AMENDMENT OF SOLICITATION/MODIFICATION OF CONTRACT				1. CONTRACT ID CODE	PAGE OF PAGES	
				J	1	3
2. AMENDMENT/MODIFICATION NO. 0002		3. EFFECTIVE DATE 23-Apr-2003	4. REQUISITION/PURCHASE REQ. NO. W81G67-2246-5833		5. PROJECT NO.(If applicable) Above West Newton

14. DESCRIPTION OF AMENDMENT/MODIFICATION (Organized by UCF section headings, including solicitation/contract subject matter where feasible.) A. The purpose of this amendment is to change the closing date from May 9, 2003, 2:00 p.m. to May 16, 2003, 2:00 p.m. and to provide additional changes per the attached Summary of Changes (pages 2-3).						
Except as provided herein, all terms and conditions of the document referenced in Item 9A or 10A, as heretofore changed, remains unchanged and in full force and effect.						
15A. NAME AND TITLE OF SIGNER (Type or print)				16A. NAME AND TITLE OF CONTRACTING OFFICER (Type or print)		
				TEL:	EMAIL:	
15B. CONTRACTOR/OFFEROR		15C. DATE SIGNED	16B. UNITED STATES OF AMERICA		16C. DATE SIGNED	
_____ (Signature of person authorized to sign)			BY _____ (Signature of Contracting Officer)		23-Apr-2003

Above West Newton Excavation

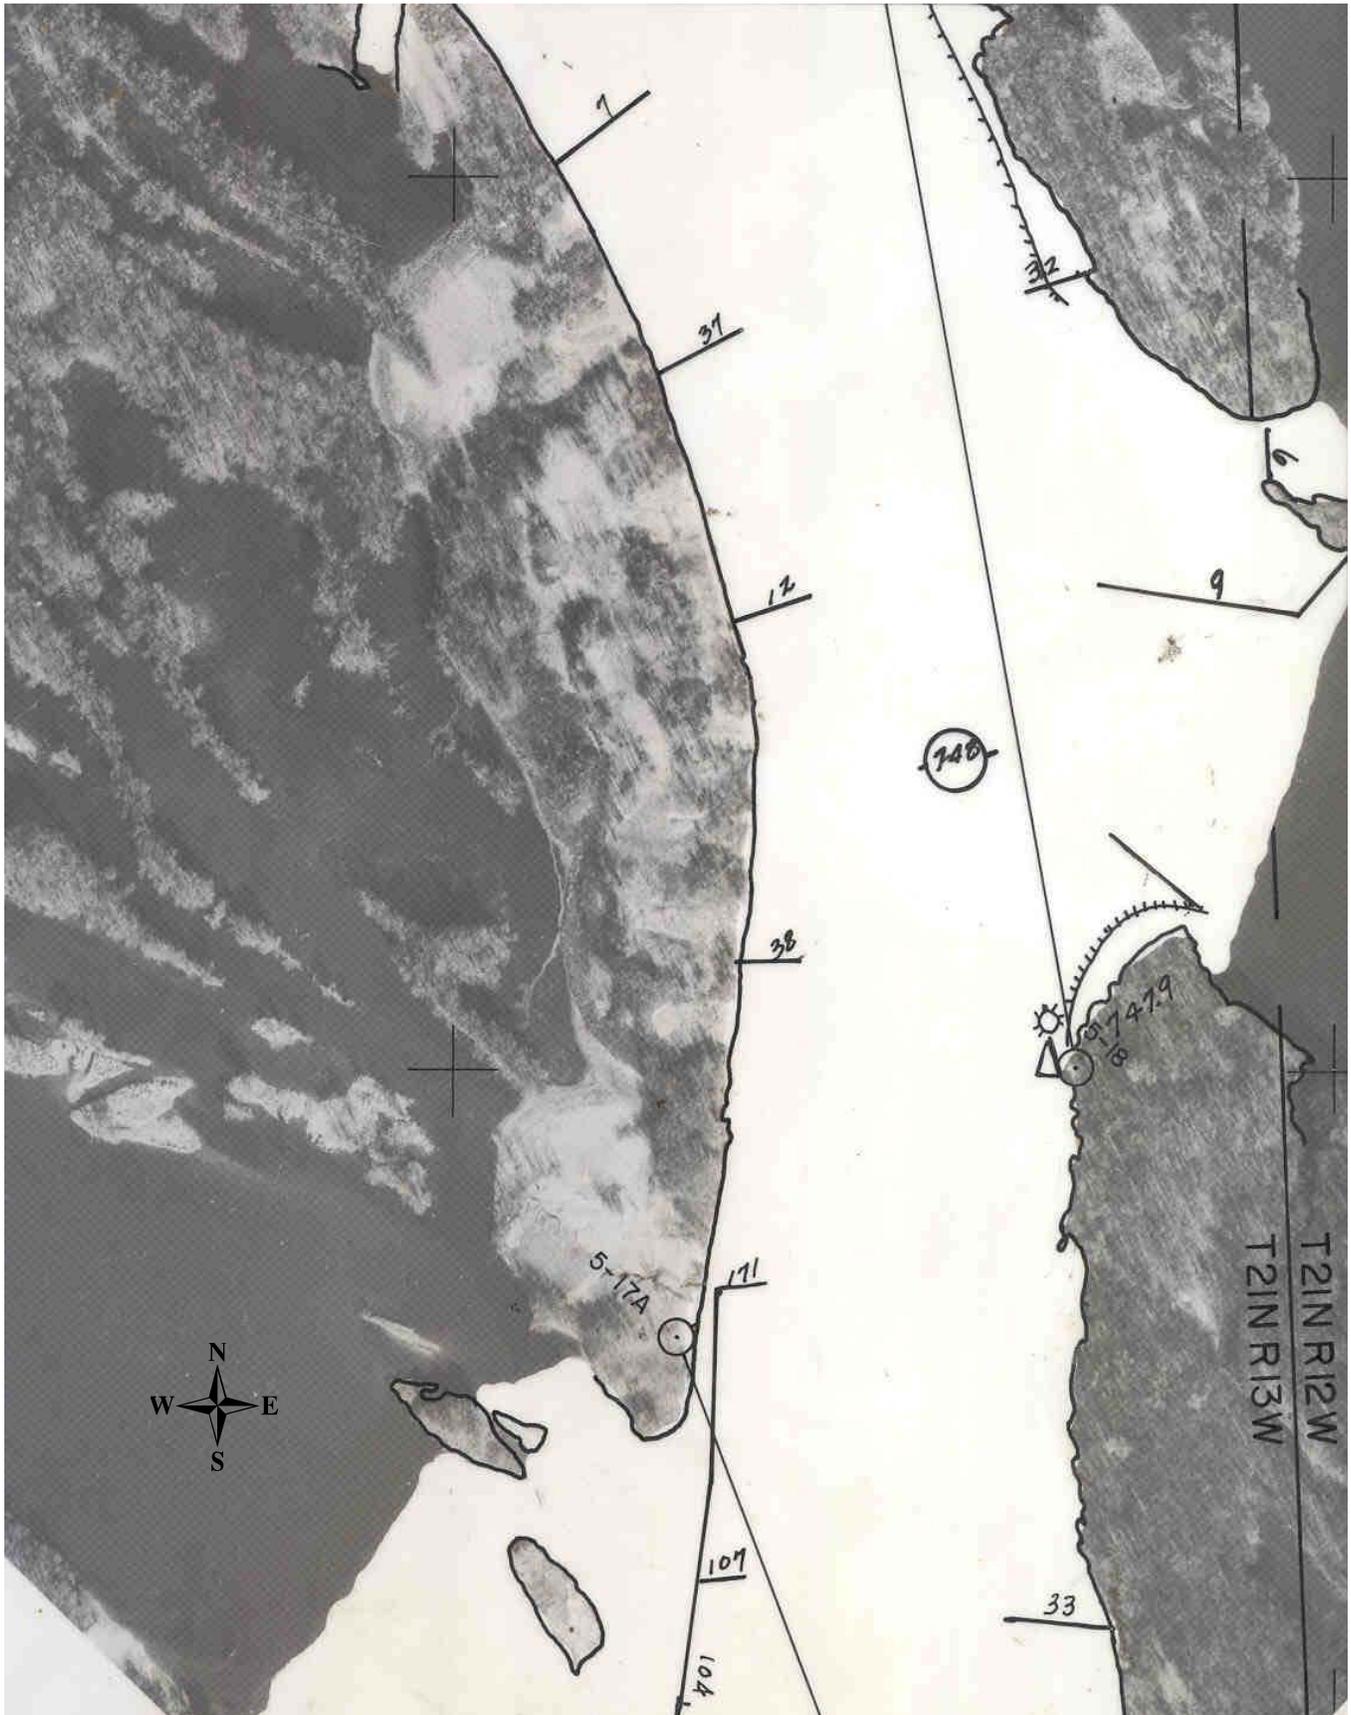
1. What, if any, information is available about the excavator site prior to material being deposited on it, such as photos, site investigation reports, and maintenance dredging reports?

3. Is there any information available to tell bidders if the area was cleared of trees and debris prior to placement of dredging spoil, etc.?

Records show that the Corps of Engineers used the Above West Newton site for placement 17 times between 1958 and 2002. The government does not have records showing where dredged material was placed between 1933 and 1956. However, it can be assumed that the site was used several times in those years. The Corps began reshaping the site in 1977 to construct a containment dike. The work was completed in 1978. The amendment includes three historic photos. The pre-dike construction photo does show trees scattered throughout the site. Several containment sites were constructed in the late 1970's and the general practice was to cut the trees down or push them over and then push them out of the site. However, at some locations, the trees were buried. The Government does not have records that indicate which method of tree removal was used during construction of the containment dike at the Above West Newton site. Therefore, trees may have been buried on-site both within the containment dike and within the remainder of the site. Historic maps also show that the Above West Newton site was built up over time on an old wing dam field. Records show that there are three wing dams that run through the site. The amendment includes a figure showing the approximate locations of the wing dams.

No records exist that show any tree or other debris removal prior to the dike construction in 1977-1978.
